G.O. No.	1259 W	Press.
B.P. No.		Mis.
Dated	30.4.1883	198.

Buildings and Roads:
Civil Works.

Despatch from the Right Honorable the Secretary of State for India, to His Excellency the Right Honorable the Governor in Council, Fort St. George, dated India Office, London, 8th March 1883, No. 10, Public Works.

FORWARDING Report of the Committee appointed to consider the question of the reconstruction of the Madras Harbour Works.

CROSS SECTION N^o 1.

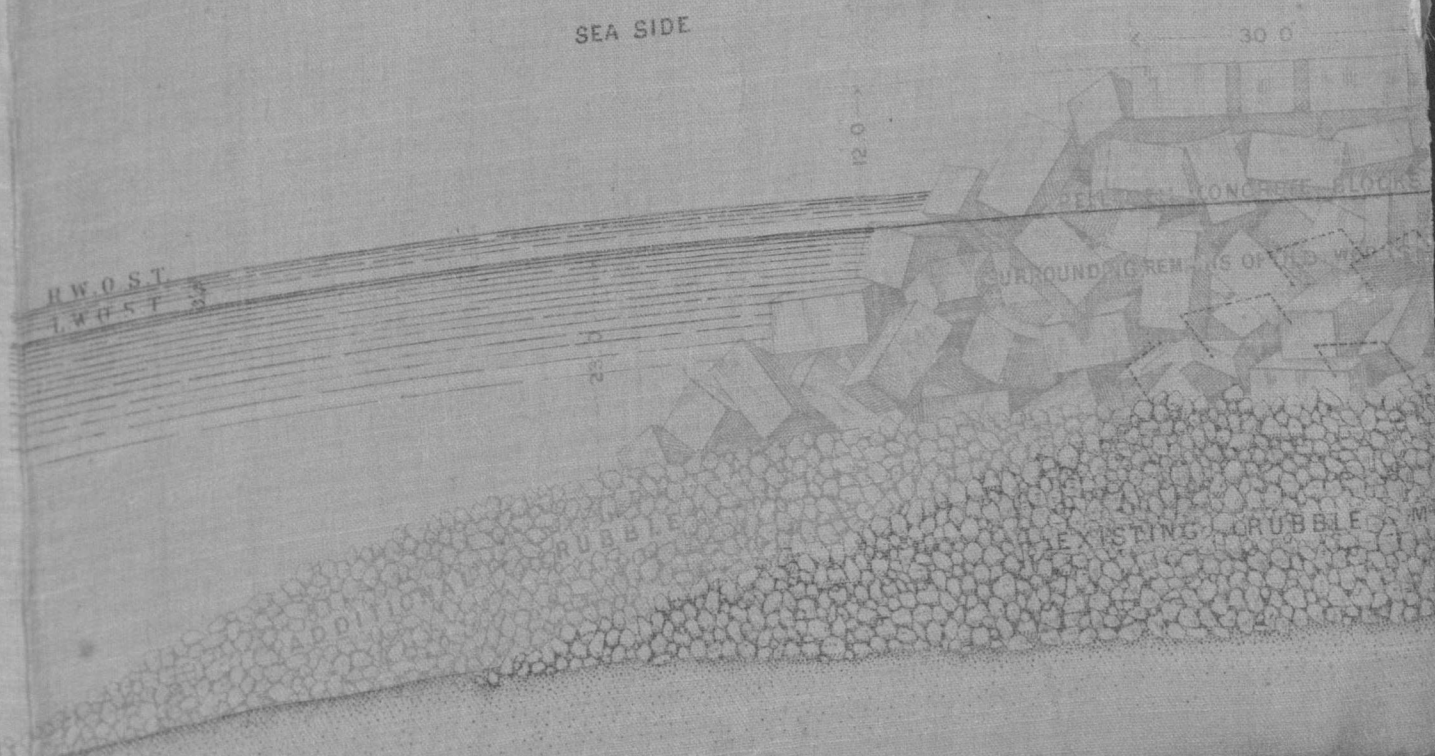
For the next length of the Piers, extending to the elbows, in addition to the cramping and the top mass of concrete, a wave-breaker, shown on Cross-Section No. 2, of random concrete blocks, should be added on the seaward face, which will render it necessary to widen the rubble mounds. The concrete blocks for the wave-breakers should nowhere be less in weight than twenty tons.

First, as regards the amount of protection to be given to the portions from the shore to point B on the north, and to point E on the south pier. The Home Committee adopt Section No. 2 (Drawing No. 2) for both alike, but, while admitting the expediency of such additional protection for the north, there is nothing to show that such is needed on the south pier. Not only has the seaward face here not in any way been attacked, but there is apparently no probability that such will occur in any storm that may arise on the coast.

CROSS SECTION N^o 4

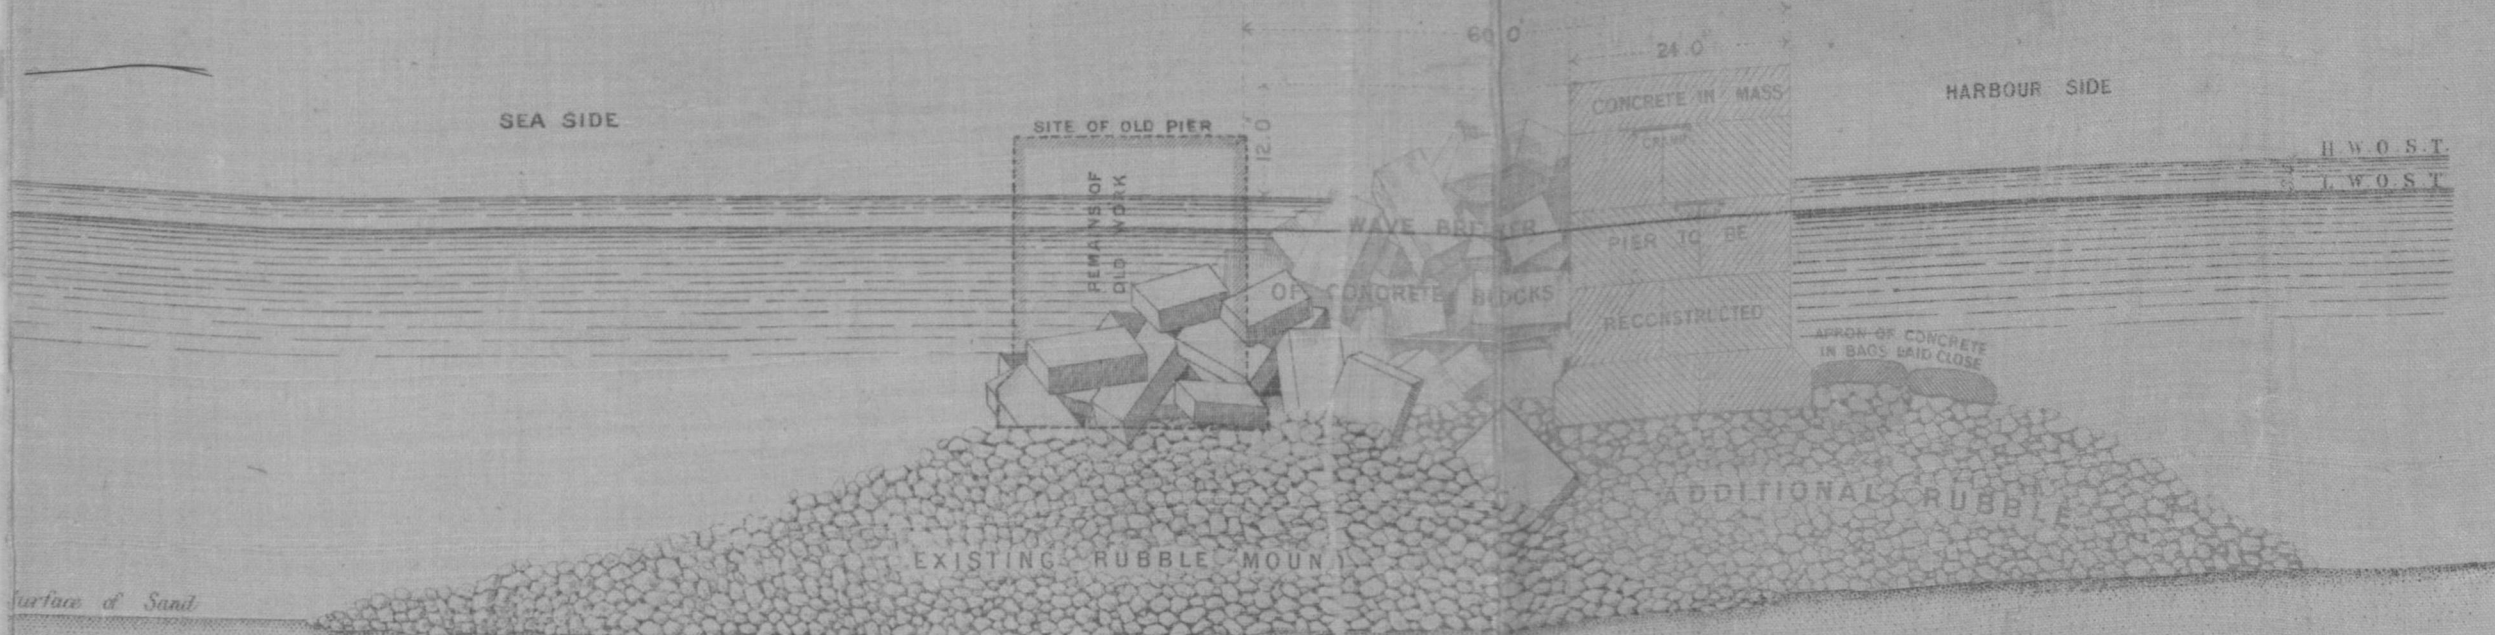
The plan, therefore, we recommend for the reconstruction of the outer lengths from B on the North Pier and E on the South Pier, to the seaward ends, is in the first instance to endeavour to continue the walls on the old foundations, as shown on Cross-Section No. 3. Before the elbows of the Piers are finished it will be seen whether this plan can be successfully carried out; if so, the system should, we think, be followed. If not, the Piers should be brought in to the extent of about 60 feet, following the design shown on Cross-Section No. 4.

Plan showing North East Entrance with protecting arm, suggested by Committee (with exceptions).

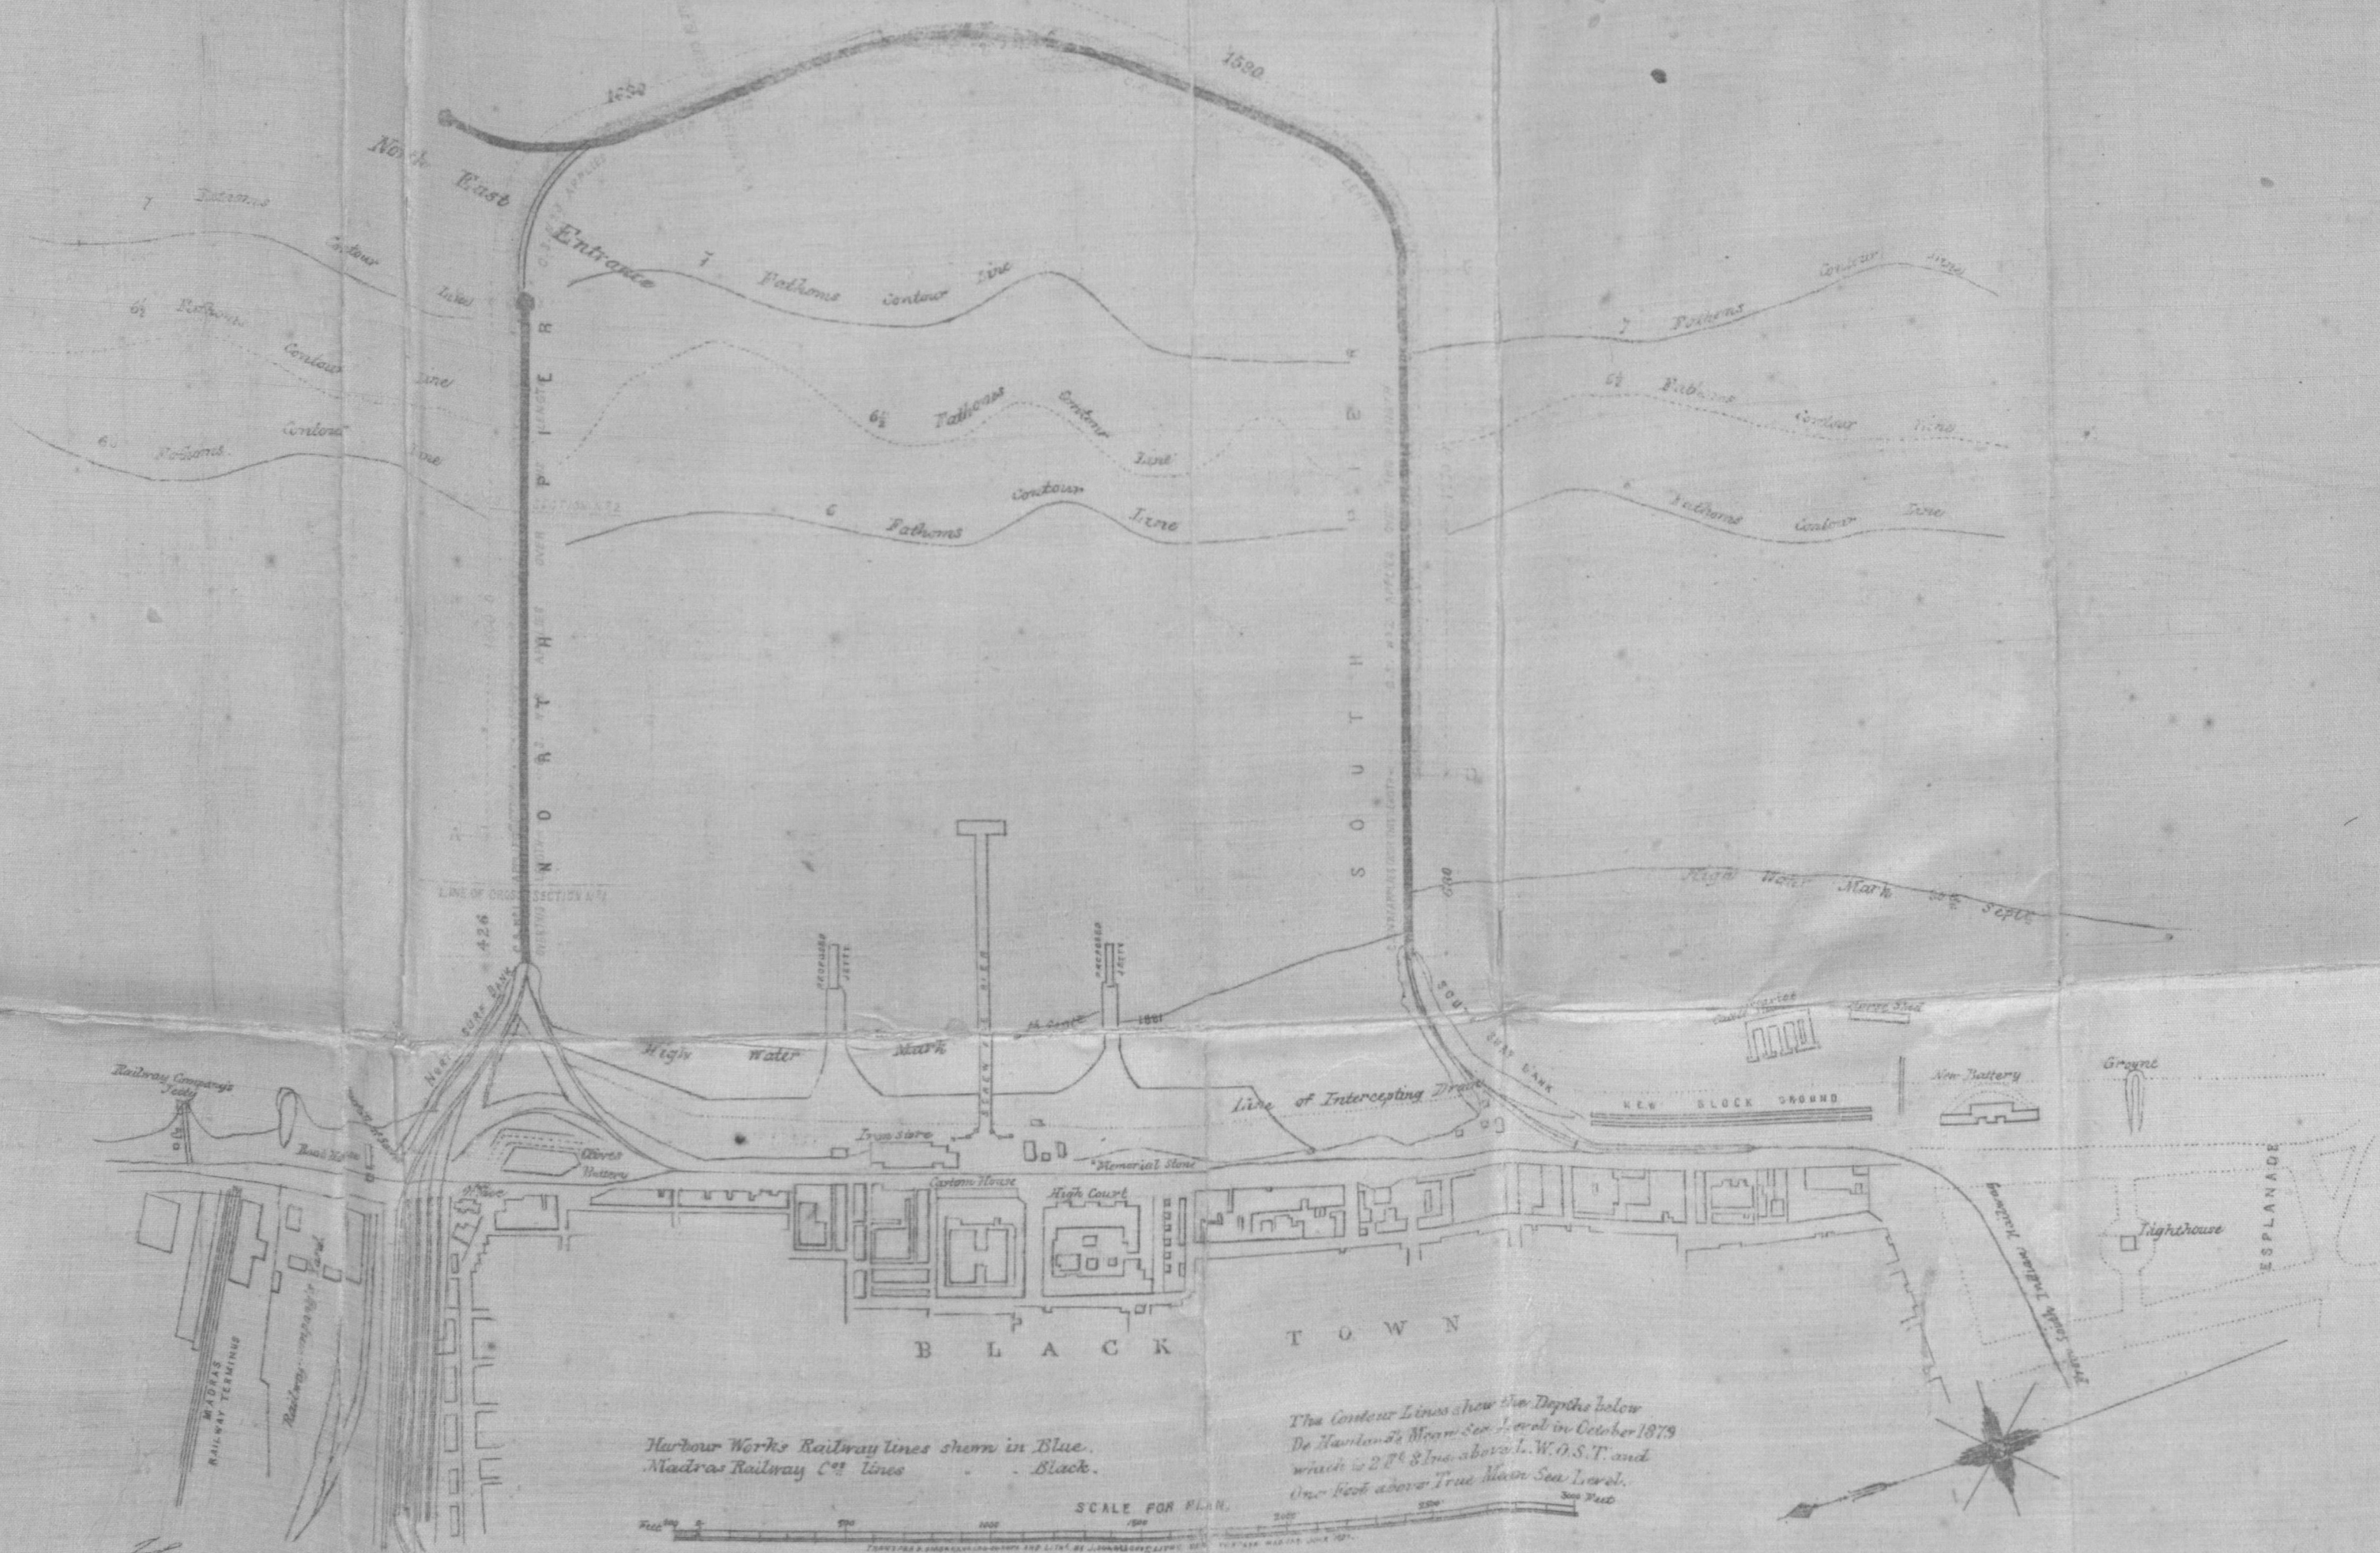
30. In this view they beg now to submit a plan for the completion of the harbour (see annexed drawings and estimates D, E, F), the leading features of which are—

- (1) By the omission of the random block wave-breaker along the south pier to E.
- (2) By the omission of the concrete cap from the shore to B on the north and to E on the south pier. The actual savings in cash outlay due to these modifications will be found further down, where is shown the probable cost of the harbour as thus completed, and here it will be desirable to advert to the formation of the proposed new entrance at the north-east angle of the harbour.
